## City of Westlake

### Planning and Zoning Department – Staff Report

**PETITION NUMBER:** SPR-2024-03 Westlake Palms (Westlake Landings, Parcel F1)

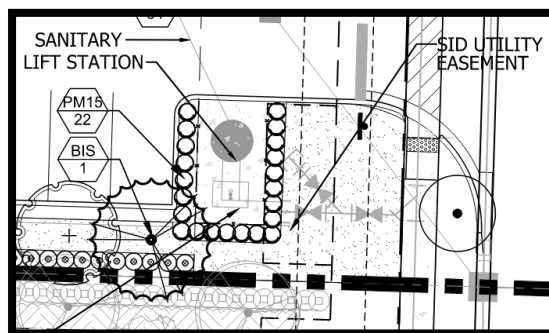
- Waiver (1) to eliminate two (2) 12' x 35, loading zones requirement from Chapter 8, Article 8.7, Section 8, Table 8-4.

*Pursuant to Chapter 8, Article 8.7, Section 8, the required off-street loading facilities may be waived or lessened in whole or part by the Planning and Zoning Director upon recommendation of the City Engineer. Any request for a waiver allowing a reduction in the number of loading spaces, size of loading area, shared use of loading facilities or other terms of this section shall require an applicant to submit a "justification statement" from a licensed professional.*

The applicant submitted a Loading Demand Analysis requesting a waiver to eliminate the requirement for two (2) 12' x 35, loading zones. The proposed building is 10,400 SF, Code requires 2 Loading Spaces for buildings 10,001 – 50,000 SF. The Loading Demand Analysis document provides the following justification for the elimination of the loading areas: *"the building's 4-sided architecture does not have a back of house. Its corner location warrants special architectural treatment and consideration. While small restaurants (> 3000 SF) may occur, the tenant mix will not demand significant deliveries other than box trucks (i.e., Fed Ex & UPS). Loading zones are rarely if ever used by these types of services."*

Proposed Site Plan

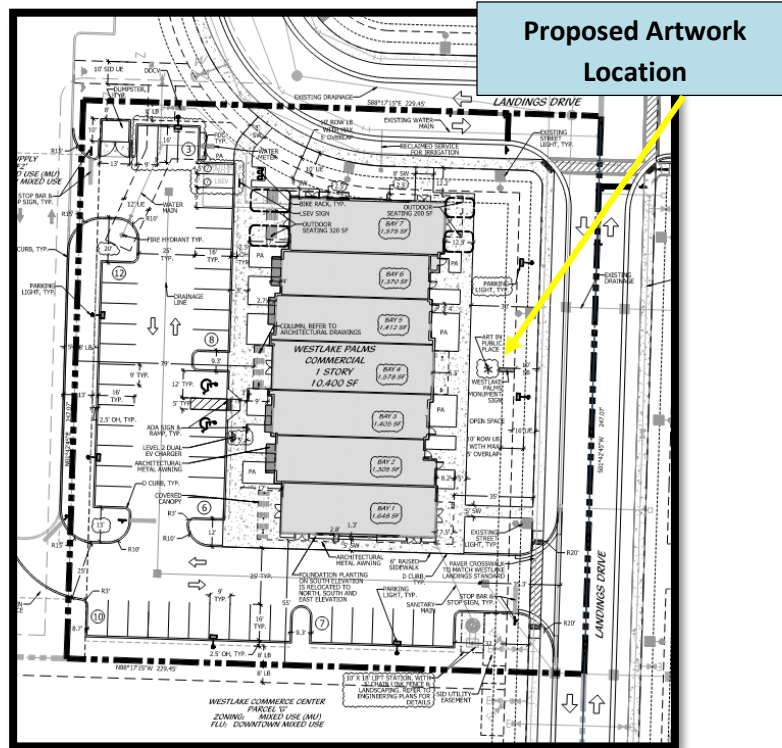
- Waiver (2) to eliminate one (1) terminal landscape island adjacent to a lift station as required in Chapter 4, Section 4.6,A),2).

*Pursuant to Section 4.26, A), 2). Landscape interior islands are required every 10 consecutive parking spaces. The number of consecutive spaces may be increased to 15 if a divider median, tree diamonds, and or larger terminal islands are incorporated into the parking lot design.*

A lift station has been placed adjacent to the other SID utilities in the SE corner of the site, directly next to the parking row area. According to the applicant's justification statement, the lift station at this location creates a more aesthetically pleasing and appropriate design, therefore is requesting a waiver to eliminate the required terminal island. The lift station at this location will be screened from view with landscape material.
